Remarks:

Reconsideration of the application is requested.

FIG.2A

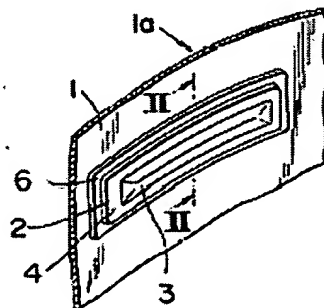
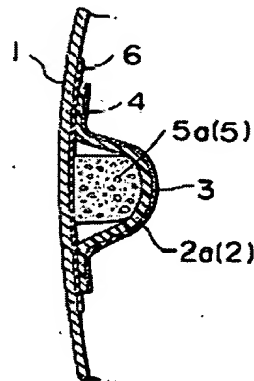
The Examiner is correct that the above-noted passages of *Miura et al.* disclose "heat-expansible material". However, the disclosure in col. 2, lines 53-55, is in the context of the first embodiment illustrated in Figs. 2A and 2B. However, in Figs. 2A and 2B the "heat-expansible material" is **not** constructed as a contoured **ring-like** plate. This can be clearly seen from in Figs. 2A and 2B re-produced below:

Fig. 2 of Hull et al. is re-produced below:

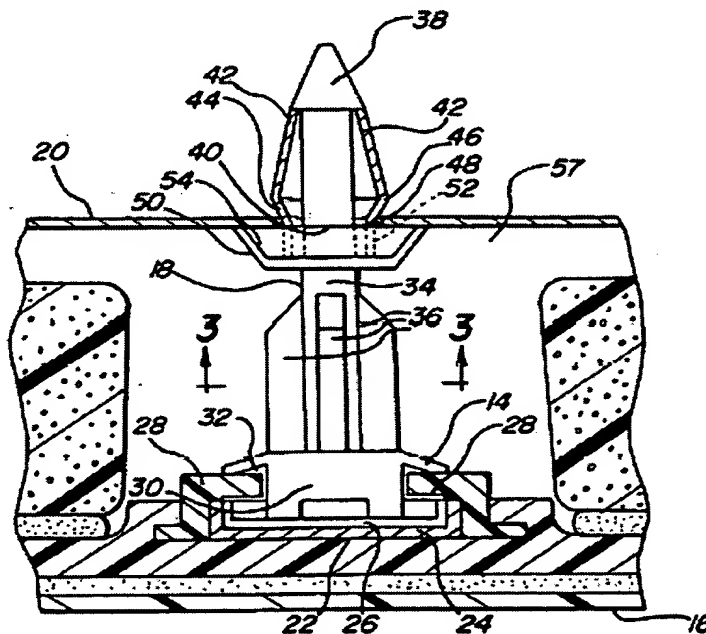
In the *Response to Arguments* in the first paragraph on page 8 of the Office action, the Examiner replied that "an expansible shaped element can be seen along either side of latching means 18 which element is of a contoured ring-like plate inserted within the retaining devices of Hull et al."

As can be seen, either side of latching means 18 are not surrounded by an expansible shaped element but (open) space. *Hull et al.* contain no disclosure regarding expandable or heat-expandable elements. Consequently, *Hull et al.* do not

disclose a heat-expansible element and, in particular, do not disclose or suggest a heat-expansible element having a contoured ring-like shape placed in the gap of two half-shells, as recited in the claims.
